Boundary of BDS group and Crab cavity group

2022/08/31

IDT WG2 DR/BDS/Dump group meeting

Comments from crab cavity group

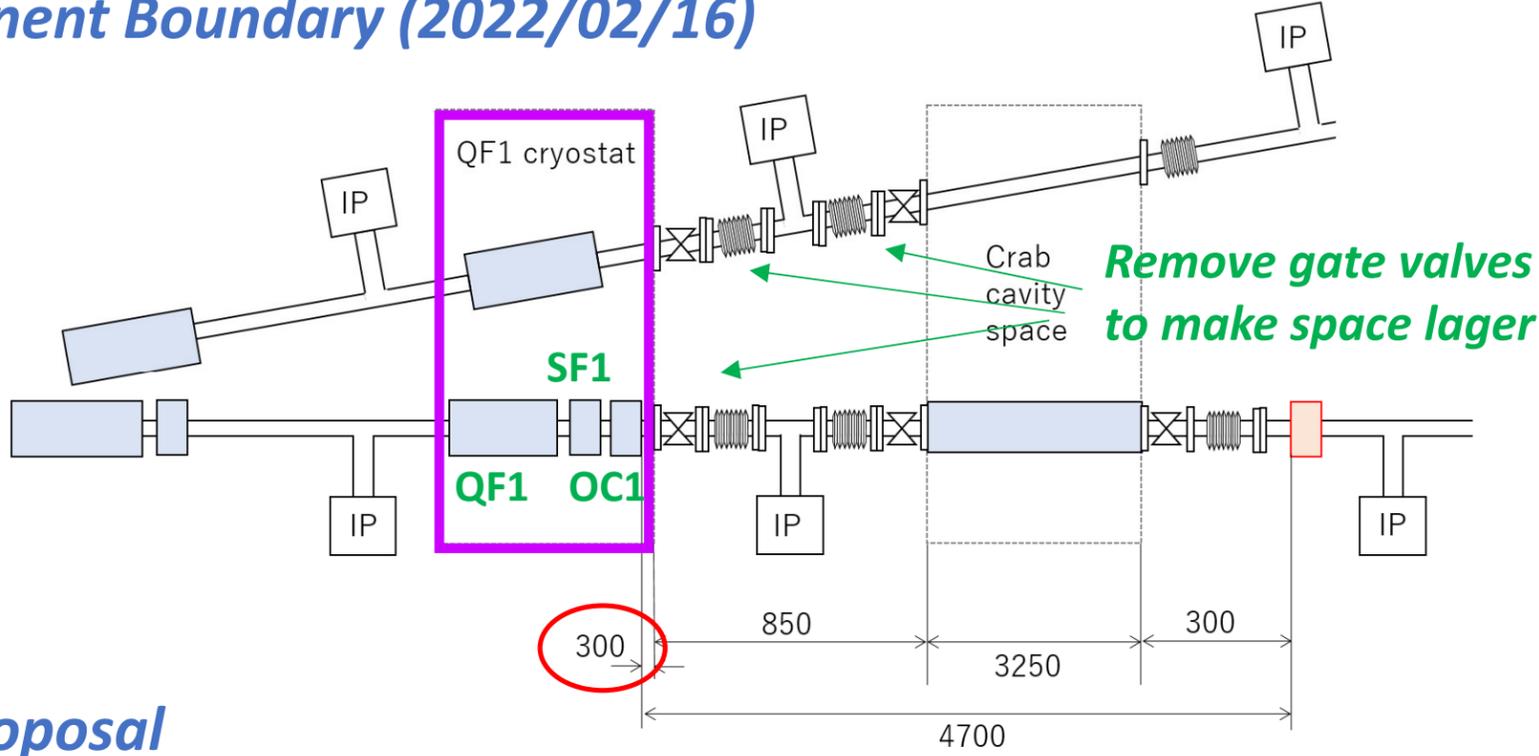
- *More detailed delineation of boundaries is needed.*
- *What kind of devices will fit in either side? For example, vacuum valves on both sides of the cavity should be included in the crab cavity device in order to protect the crab cavity.*
- *They would like to have as long a space as possible for the crab cavity.*

QF1 cryostat arrangement (basically no change)

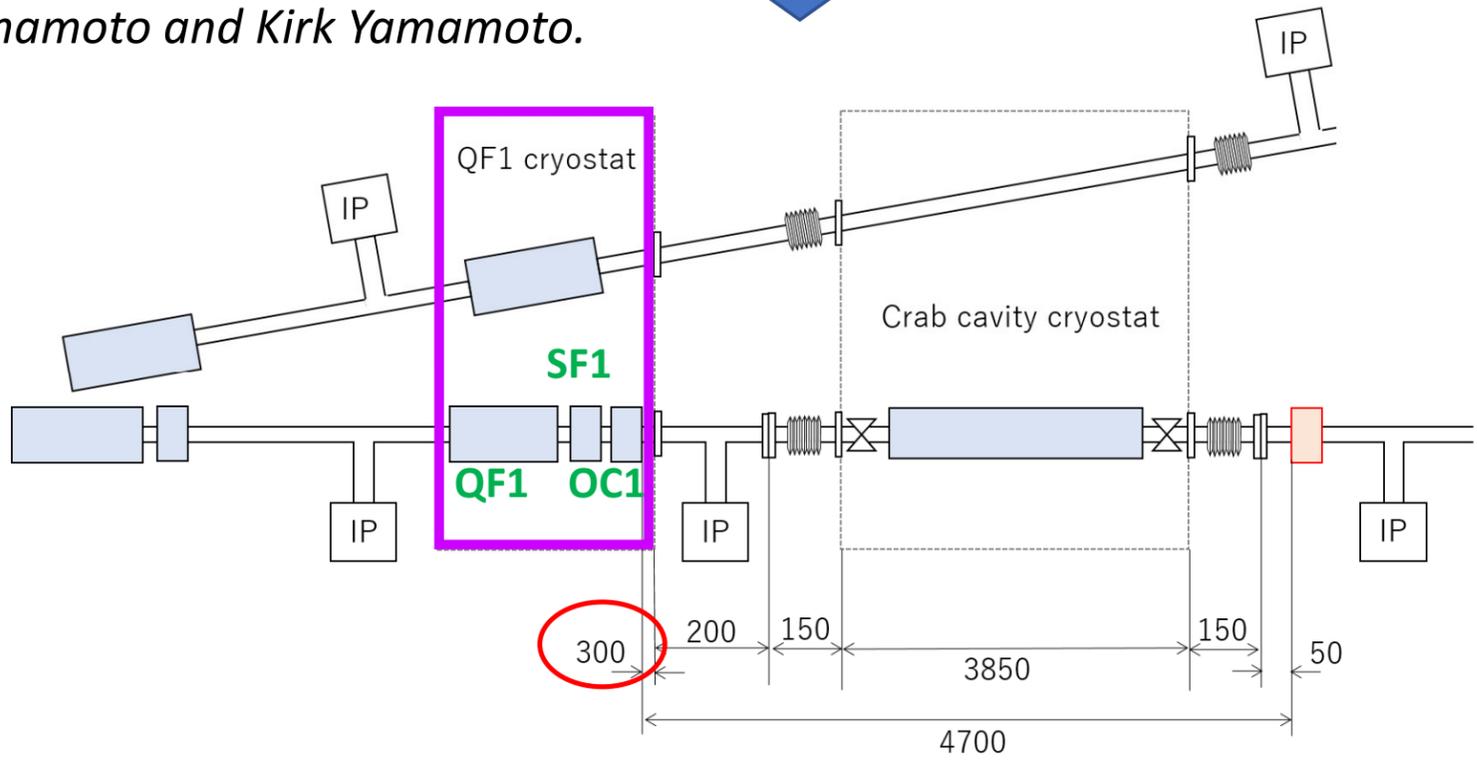
- *SC final focus magnet should not be connected to Crab cavity by cryogenic shield from point of view for alignment and thermal shrink (A warm section should be placed in between).*
- *In SuperKEKB's QCS, the pipe itself is at room temperature, and the vacuum valves are not located on both sides of magnet.*
- *Even if you put in a low-temperature pipe, the boundary should be set to room temperature.*
- *In their experience with the QCS magnets in SuperKEKB, 30 cm is a sufficient space. The crab cavity side also has a space of about 30 cm to accommodate the thermal shield with gate valve as a base design (explain later).*
- *If a space of 30 cm is secured, we do not think that there will be any restriction on the QF1 cryostat (Would like to hear Brett's opinion).*

The boundary was fixed by discussing with Akira Yamamoto and Kirk Yamamoto.

- The boundary of the QF1 and crab cavity cryostat will not connect with thermal shield, but will have the **“warm section”** as original design.
- The incoming beamline of the QF1 cryostat has three independent magnet arrangements, QF1, SF1, and OC1.
- A space of 30 cm is provided in the optics deck from the pole face of OC1 to the cryostat boundary. The space will **not change for the proposal to the cryostat arrangement for the crab cavity group.**
- Even if you put in a low-temperature pipe, the boundary should be set to room temperature with the 30 cm space. We should design the QF1 cryostat by taking account of the thermal shield of the pipe.
- If SF1 and OC1 are combined, the space for the thermal shield can be even longer (leaving flexibility in the design).
